Combroke Parish Council

Consultation for Planning Application 14/02265/FUL - new submitted drawings

Proposed: Demolition of existing agricultural buildings and erection of 4 residential dwellings (amendment to previously approved 13/02619/FUL for re-positioning of plots 1,2 & 3 and re-design of Plots 3 & 4 together with erection of log store to rear of site)
at CE Gilbert Development site North West of Village of Combrook CV35 9HN

APPENDIX A : C E Gilbert & Son Combrook Site Overlay: December 2014 Survey and Approved Plan

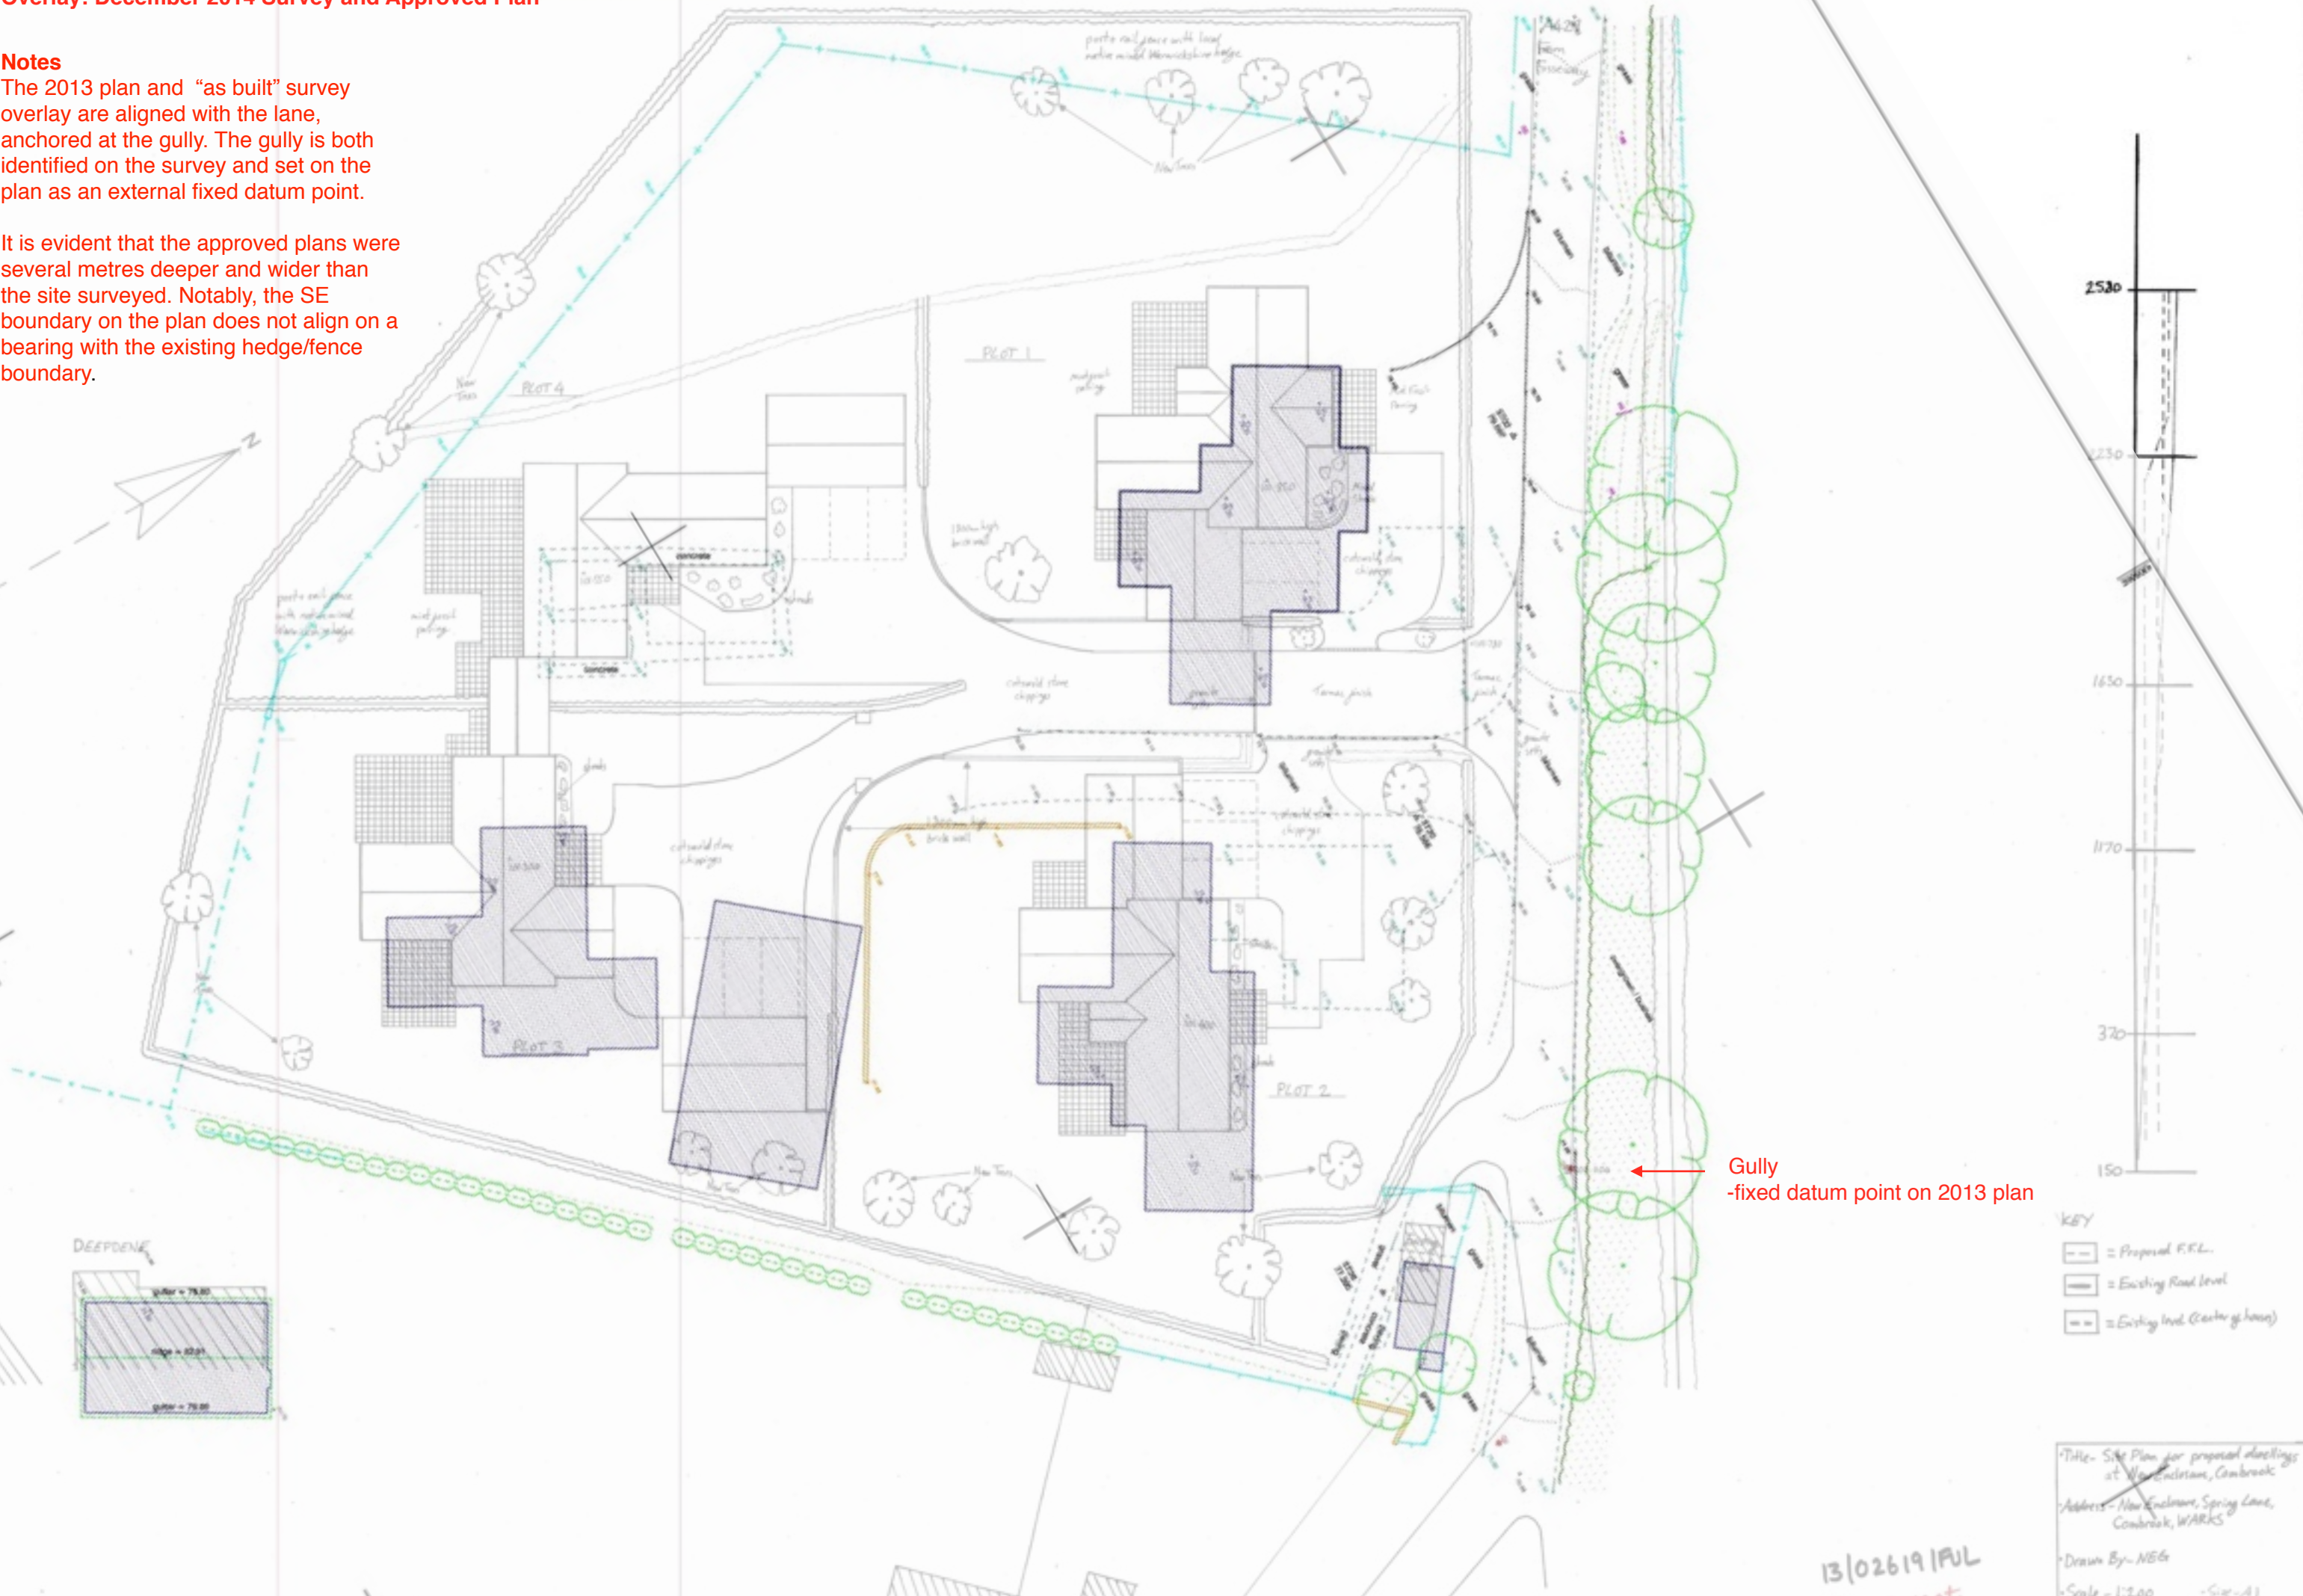
4.3. Provided at Appendix A is an overlay of the survey on the approved 13/02619/FUL plan. At the Parish Council meeting to consider this application, an accurate tracing of the site survey was aligned over the approved plan to demonstrate the problem with the approved drawing.

4.4. The approved drawing was neither the right size for the site nor correctly aligned in relation to the lane. Consequently if 13/02619/FUL were to be accurately implemented as approved the plots would all be built some 5m to NW of the 'as built' positions - they would at least have a less harmful impact on neighbouring properties if this were to happen.

Notes
 The 2013 plan and "as built" survey overlay are aligned with the lane, anchored at the gully. The gully is both identified on the survey and set on the plan as an external fixed datum point.

It is evident that the approved plans were several metres deeper and wider than the site surveyed. Notably, the SE boundary on the plan does not align on a bearing with the existing hedge/fence boundary.

The plot sizes and boundaries for the nearest neighbours and this scheme (approximate)

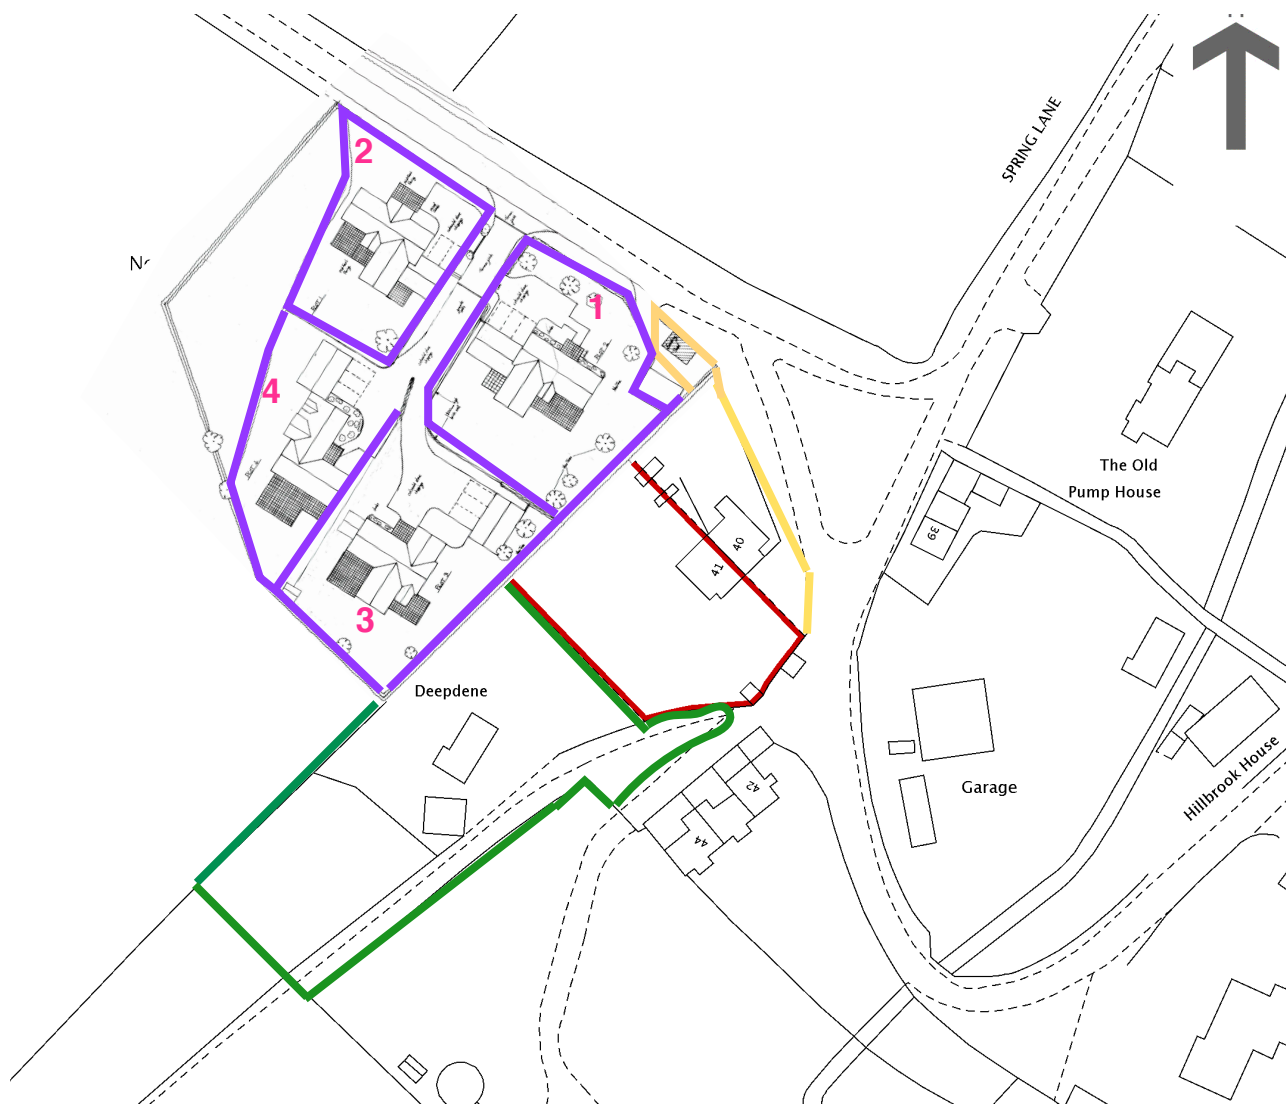
NB the above is taken from a Land Registry OS map, however the position of Deepdene on the ground is closer to its NW boundary

From the above it can be seen that the existing neighbouring dwellings 40, 41 and Deepdene occupy generous plots at this edge location of the village. And that these dwellings are positioned comfortably within their plot.

The plot size of the new proposed dwellings (in purple) are cramped given the huge size of these proposed detached dwellings. They will appear as **dense suburban**⁵ in contrast to the character of the existing plots.

It is critical to save the character in this location from further erosion and ensure that the position of the dwelling in plot 3 is not allowed, through this proposed amendment, to encroach any further towards Deepdene than is already permitted under the approved scheme 13/02619/FUL
